**Subject: Results of Additional Investigation**

Eva Manor, 2103-2133 91st Street, Pleasant Prairie, Wisconsin

BRRTS #: 02-30-543562 / FID #: 230115930

FIGURE B.1.B – DETAILED SITE MAP

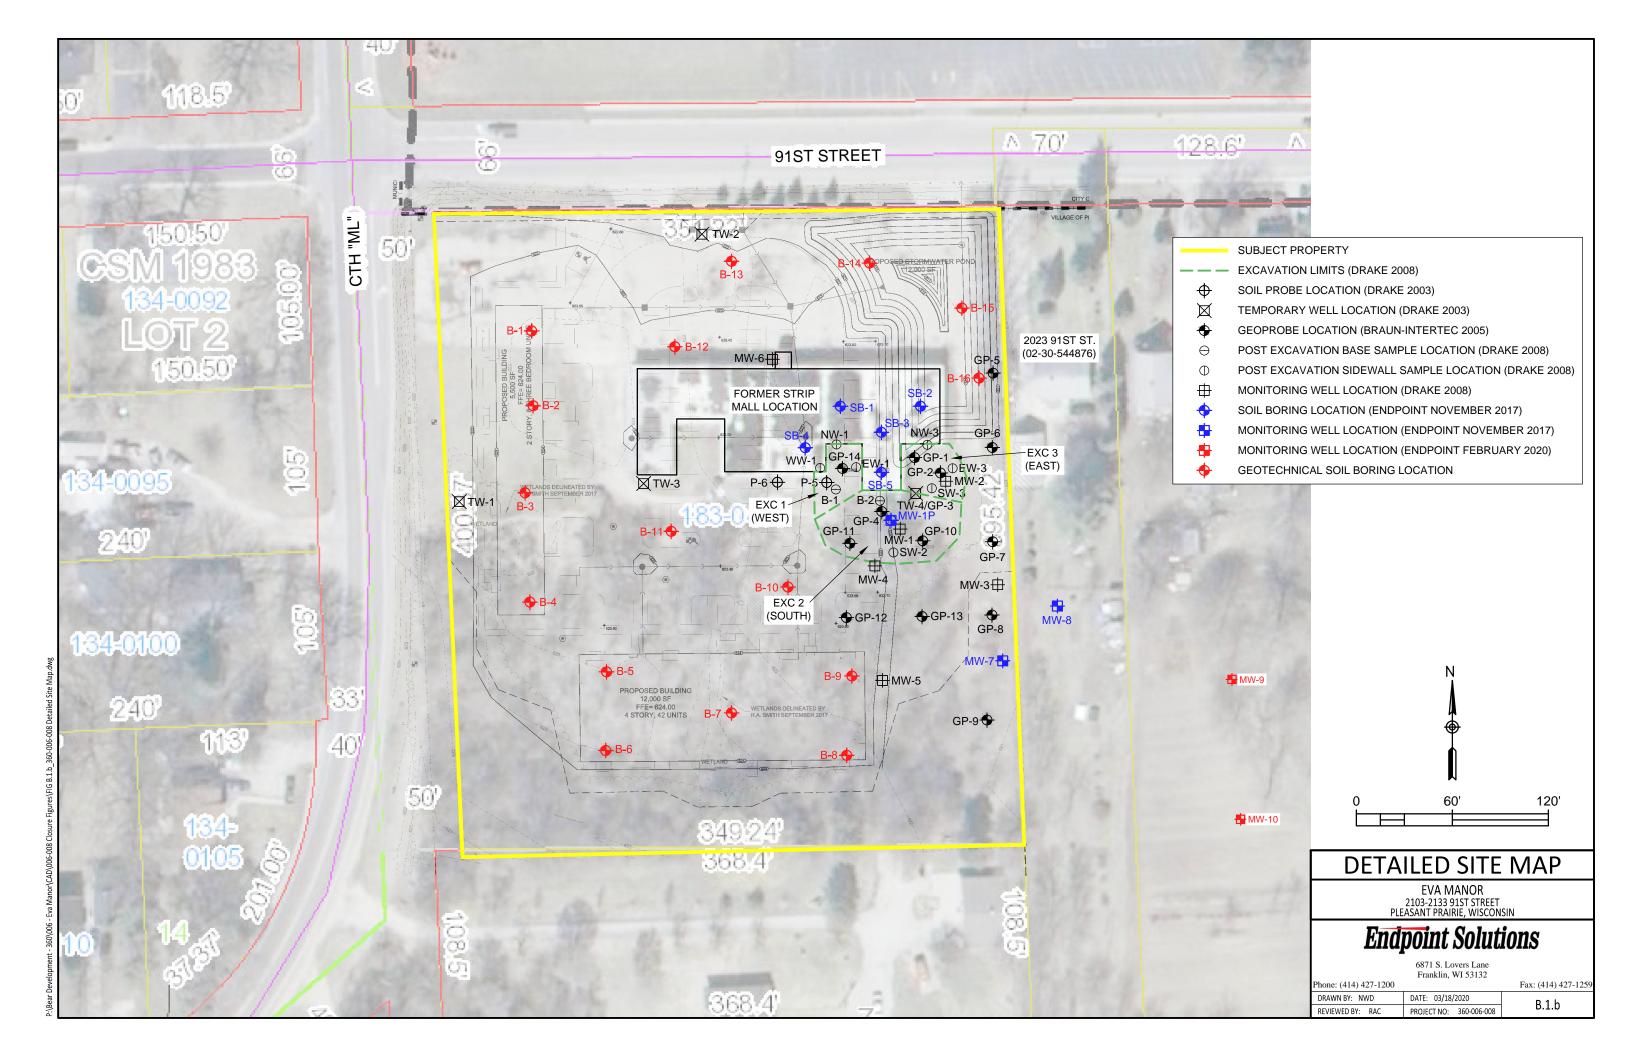
- A. Additional Groundwater Sampling and Monitoring. In order to define the down-gradient extent of groundwater contamination off the Site, we recommend that two (2) additional Wisconsin Administrative Code (WAC) Chapter NR 141 compliant monitoring wells be installed in the area southeast and northeast of MW-8 on the property located at 2019 91st Street. All groundwater samples should be laboratory analyzed for chlorinated VOCs, including tetrachloroethene (PCE). Additional rounds of groundwater samples should be taken from remaining monitoring wells MW-2, MW-3, MW-8 and any new monitoring wells that are installed to demonstrate degree and extent of groundwater contamination and to verify that the groundwater plume is stable or receding.

A. Additional Groundwater Sampling and Monitoring. On February 27, 2020, two (2) WAC Chapter NR 141 compliant monitoring wells identified as MW-9 and MW-10 were installed on the 2019 91st Street property. The proposed locations of the monitoring wells were reviewed and approved by the WDNR and were subsequently located in the field with survey-grade RTK-GPS equipment. The locations of the newly installed wells are depicted on **Figure B.1.b**.

FIGURE B.3.C – GROUNDWATER FLOW MAY – 03/09/2020

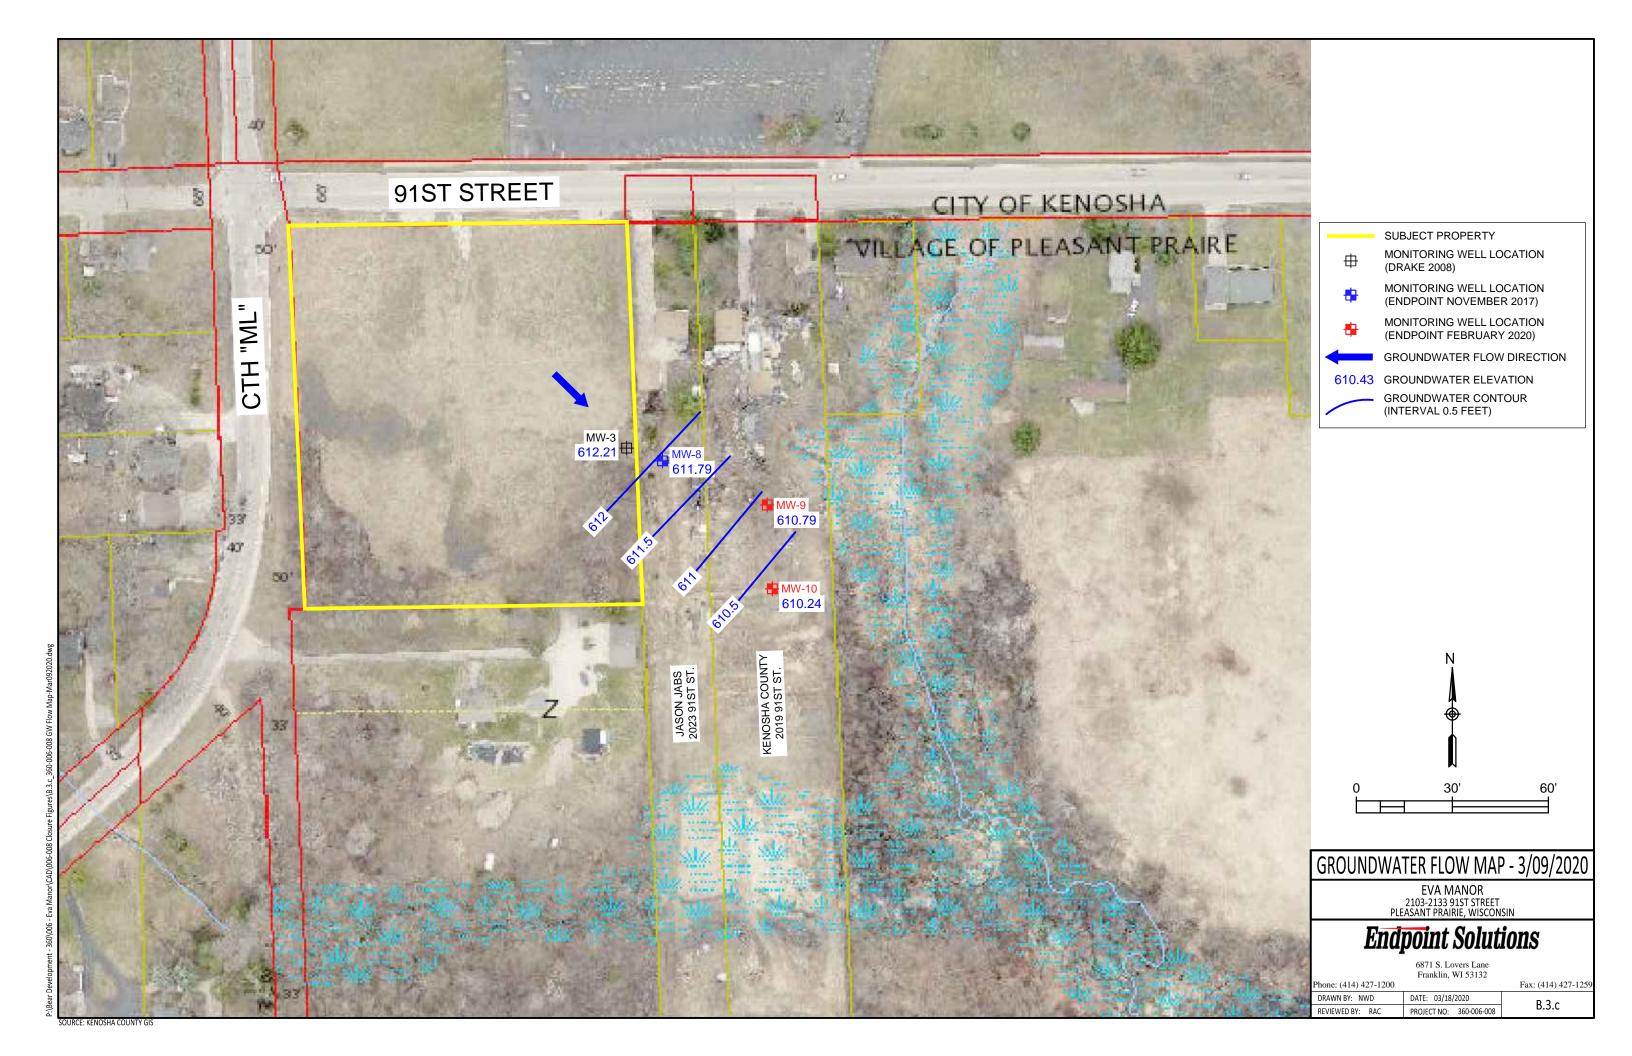
- B. <u>Conduct Vapor Assessment Offsite</u>. Additional vapor assessment may be needed after additional groundwater sampling. A vapor investigation is recommended if any structures overlie groundwater contaminated with chlorinated concentrations above WAC Chapter NR 140 enforcement standards (ESs) at the water table or if the chlorinated groundwater contamination is above WAC Chapter NR 140 preventive action limits (PALs) and in contact with a structure.

Based on the groundwater elevations collected during the sampling events, the groundwater was determined to be flowing to the southeast from the Site across the two (2) adjoining properties to the east (2023 91st Street and 2019 91st Street). A depiction of the groundwater flow direction is provided on **Figure B.3.c**.

FIGURE 1 – UTILITY MAP

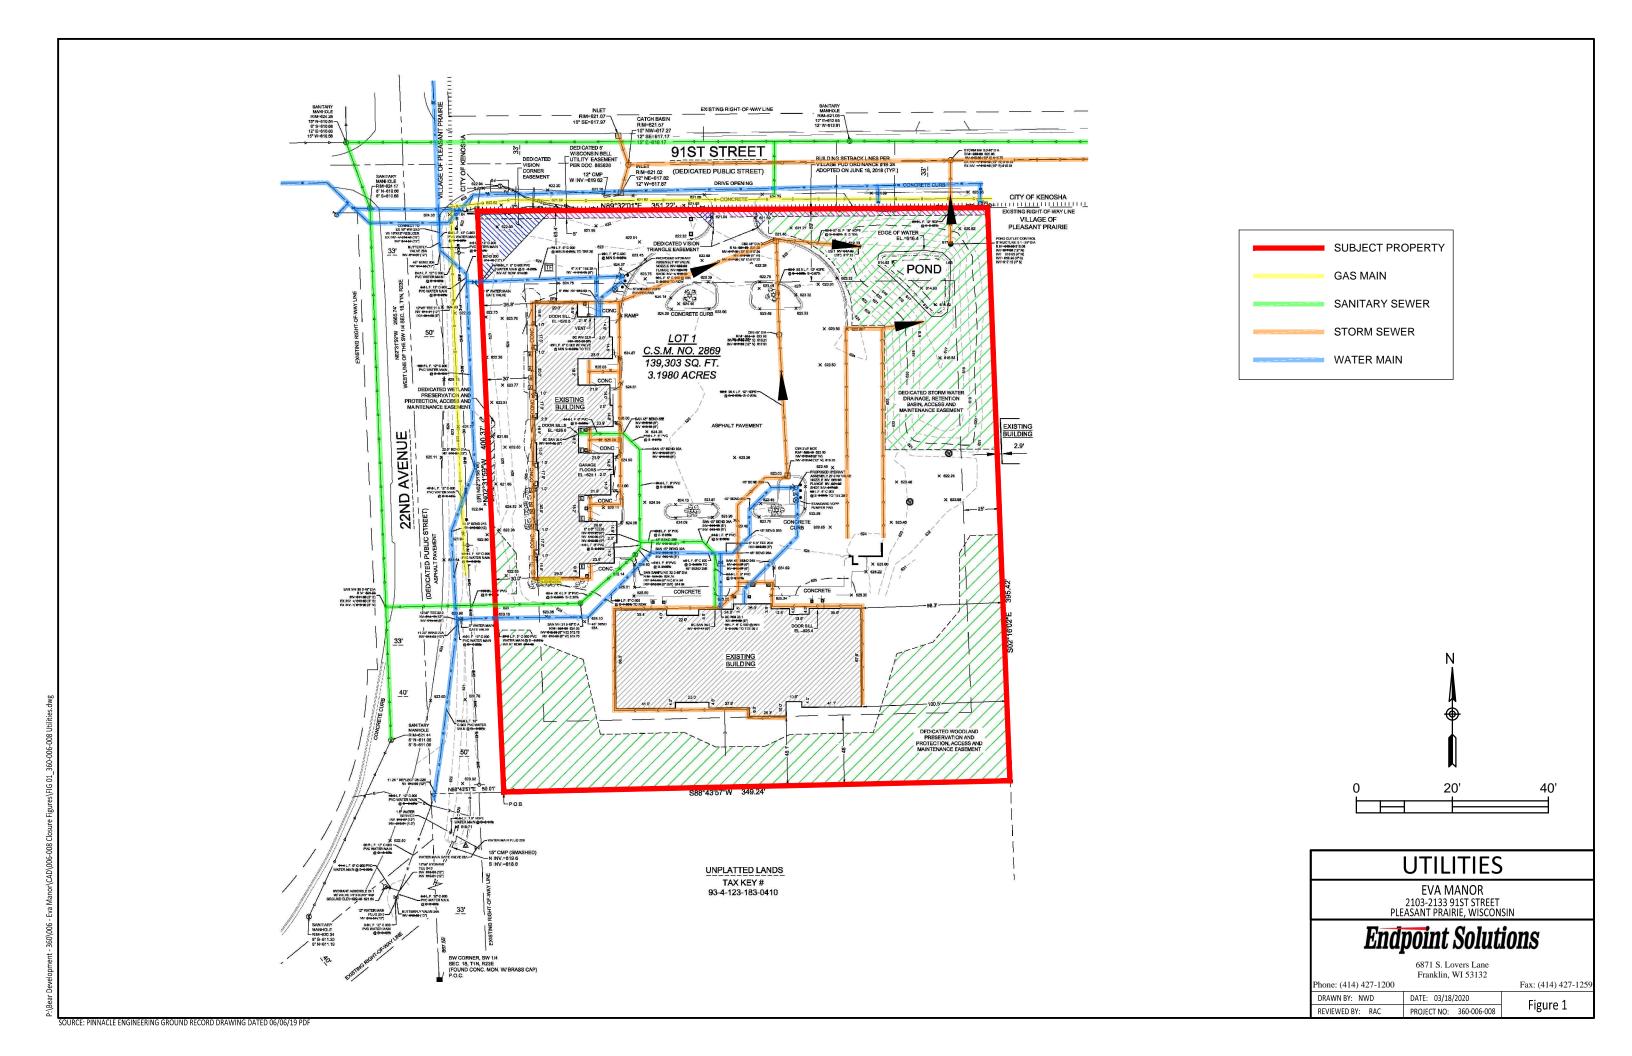
- C. <u>Identify Migration Pathways.</u> After the offsite groundwater is complete, evaluate the potential or known impacts to receptors, including onsite and offsite subsurface utilities. This includes the new utilities to the buildings onsite and utility connection on the offsite properties in order to complete the vapor screening evaluation.

C. <u>Identify Migration Pathways.</u> As previously discussed, groundwater elevation and analytical data supports the migration of the plume of contamination to the southeast from the southeast corner of the former strip mall structure on the Site. While the upgradient extent of the plume of contamination underlies newly constructed slab-on-grade garage structures on the Site, the garages do not contain any deep underground utilities associated with potable water or storm or sanitary sewers that could act as preferential migration pathways for groundwater or vapors. A copy of the Utility Plan for the redevelopment of the Site is attached as **Figure 1**.

Based on requested Digger's Hotline utility markings and a visual review of existing conditions, it has been determined that subsurface potable water and sanitary sewer laterals enter the structures on the Site and the adjoining properties to the east at 2023 91st Street and 2019 91st Street from the 91st Street right-of-way located to the north of the properties. There are no known underground utilities extending to the south from the structures along 91st Street on the 2019 and 2023 91st Street properties. Based on this information, it is our opinion there are no active migration pathways for subsurface vapors; therefore, the vapor screening evaluation is complete.
